INCH-POUND
MIL-C-17/134C
AMENDMENT 2
29 April 1999
SUPERSEDING
AMENDMENT 1
12 July 1994

MILITARY SPECIFICATION SHEET

CABLE, RADIO FREQUENCY, TRIAXIAL, .245 INCH, 50 OHM, WATERBLOCKED, NON-WATER BLOCKED AND CROSSLINKED, LOW SMOKE

This amendment forms a part of MIL-C-17/134C, dated 13 April 1993, and is approved for use by all Departments and Agencies of the Department of Defense.

FIGURE 1. General configuration.

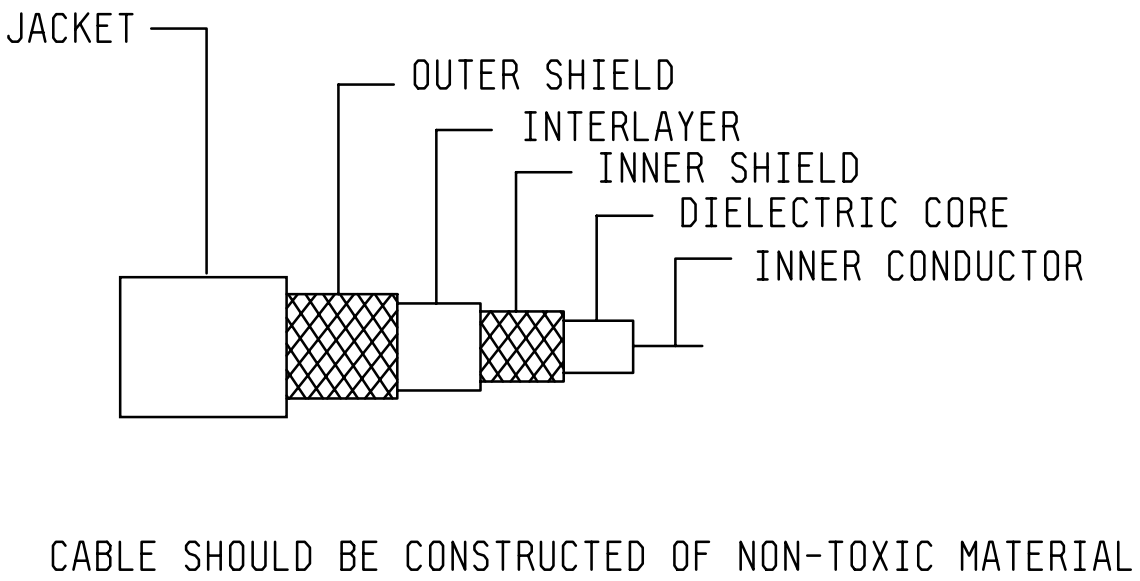
FIGURE 1, delete and substitute as shown on the following page.
